Malcolm/Glendon

Staff Report Reply

Project Description, Location & Timeline

Developer's Report (Malcolm)

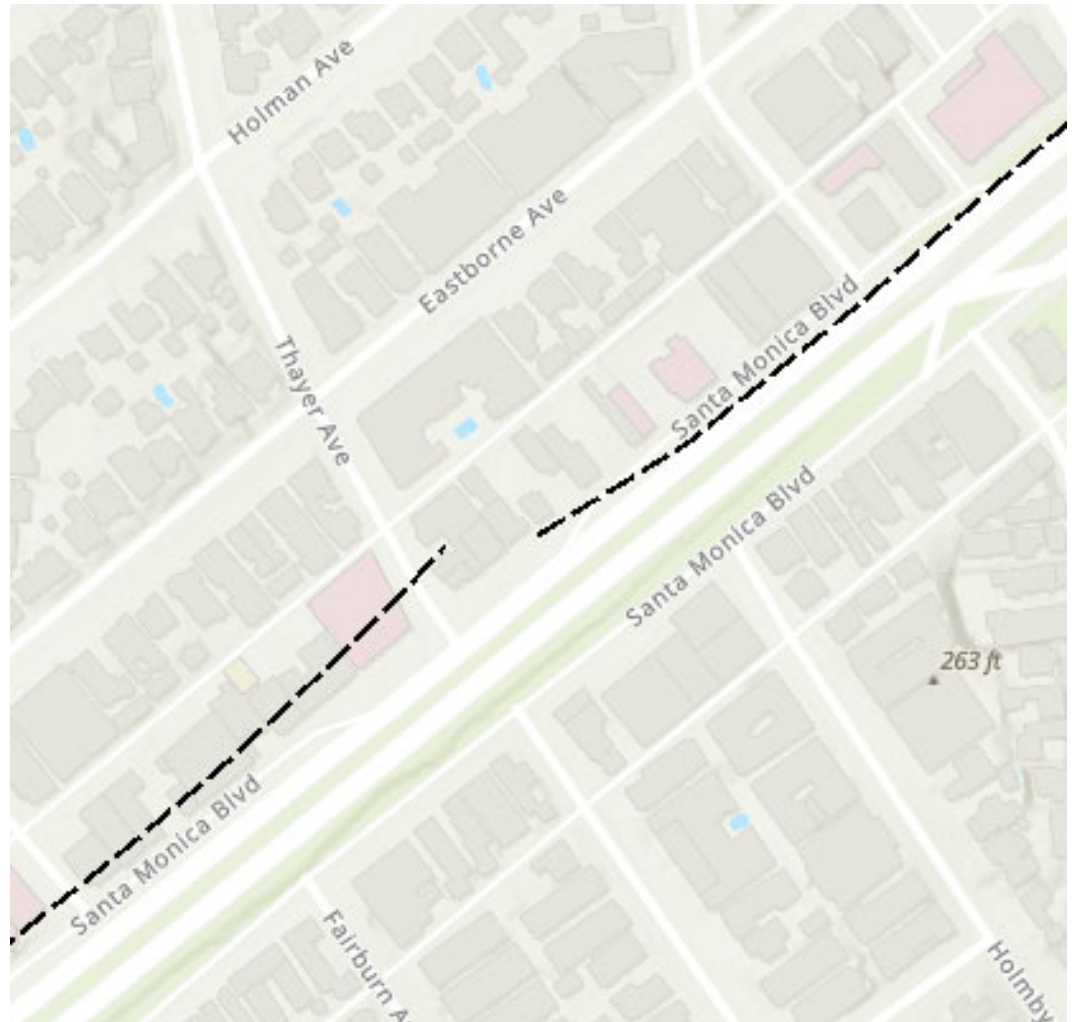
Based on wrong dataset.

Improperly allowed building over a fault trace and/or in a no-build zone.

Did not study west of the eastern property line.

Failed to study fault traces starting on the property or entering from the south.

Failed to provide any “evidence of absence” of faulting on the property west of the eastern boundary.

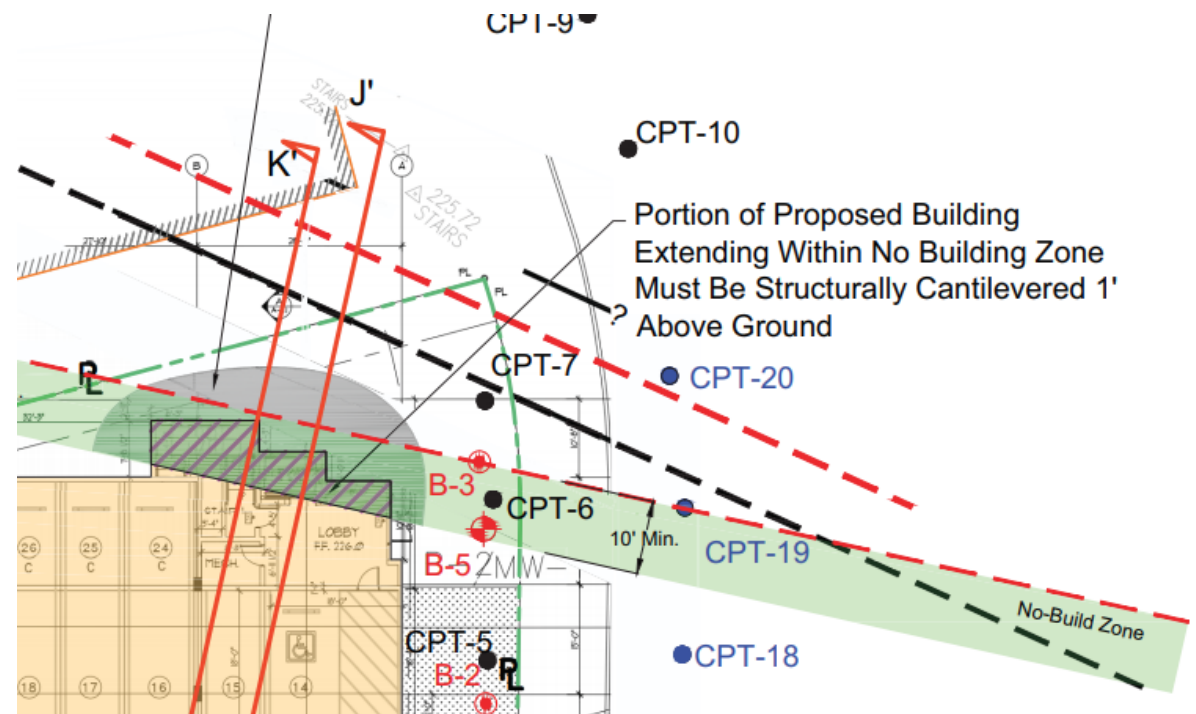
Fault traces can start within a property or enter within a boundary.

Exploration on one side does not disprove the presence of fault traces.

No study was done west of “CPT-7” just inside the eastern property line to determine “location, trend, nature” of the fault trace as required.

Developer's Report (Glendon)

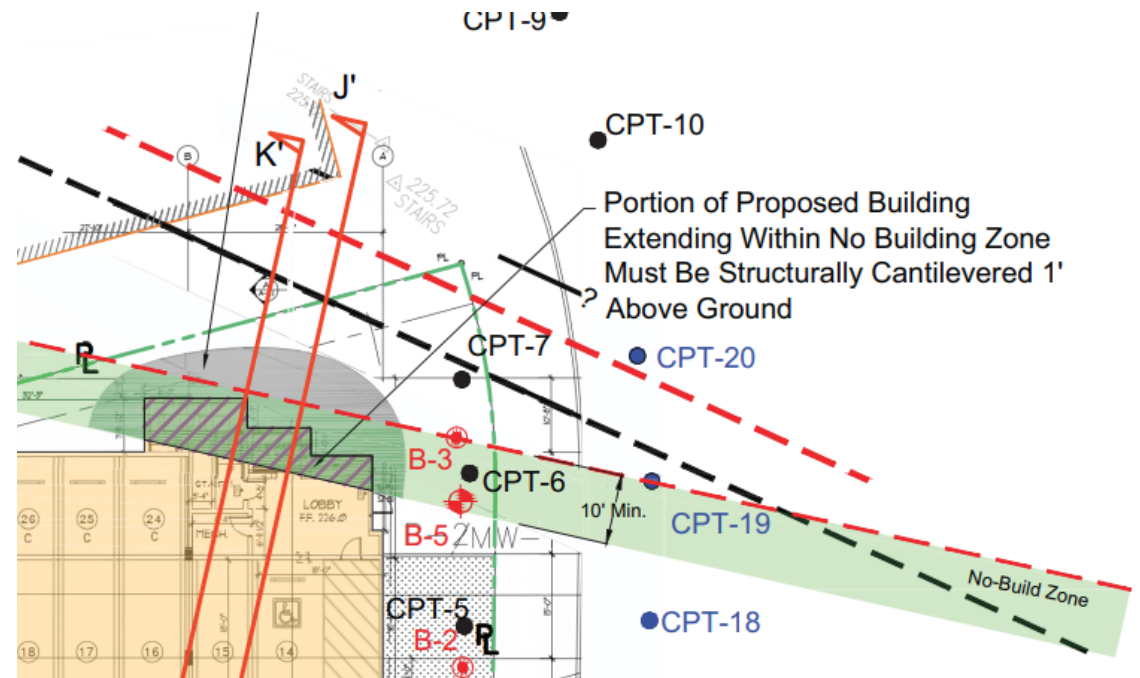
- Required investigation not performed at all.

The Project is
built in a no-
build zone at
the fault
trace
resulting in
zero setback

Building Over a Fault Trace or in a “No Build Zone” is Disallowed

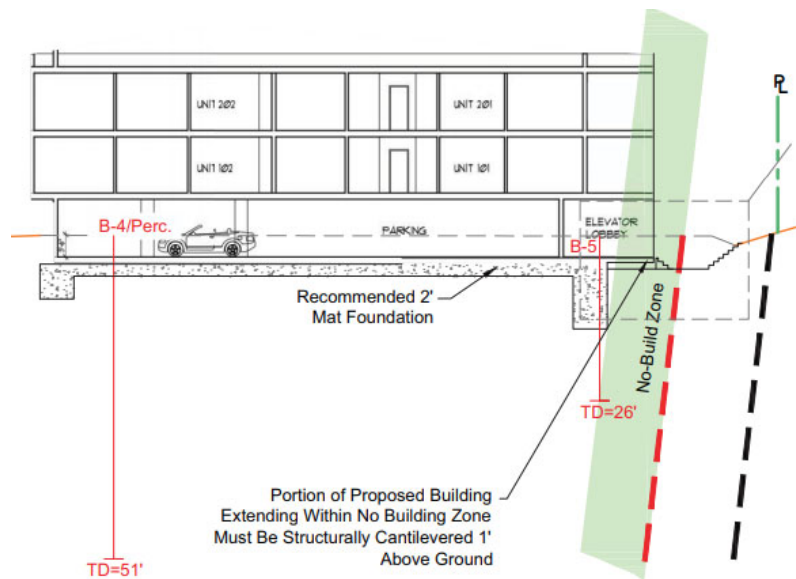
- The city improperly allowed construction on/at an active fault trace.
- The city improperly allowed construction in a “no-build zone”
- The developer failed to build the called-for “cantilever”

Required Cantilever* Is Not Visible

Note: Building over a fault trace is never allowed – even with a cantilever.

The at grade structure IS connected to the cantilevered section.

As the consultants recommend building a cantilevered structure within the “No-Build Zone”, the consultants shall provide recommendations as to the maximum vertical and horizontal offset of the fault; and, a recommendation for vertical and horizontal space to be maintained below the cantilevered structure. Provide a plan that depicts the required space maintained below the cantilevered structure. Note: The current plan appears to show a lobby with doorways in the cantilevered area. No at grade structures can be connected to the cantilevered section of the proposed building.
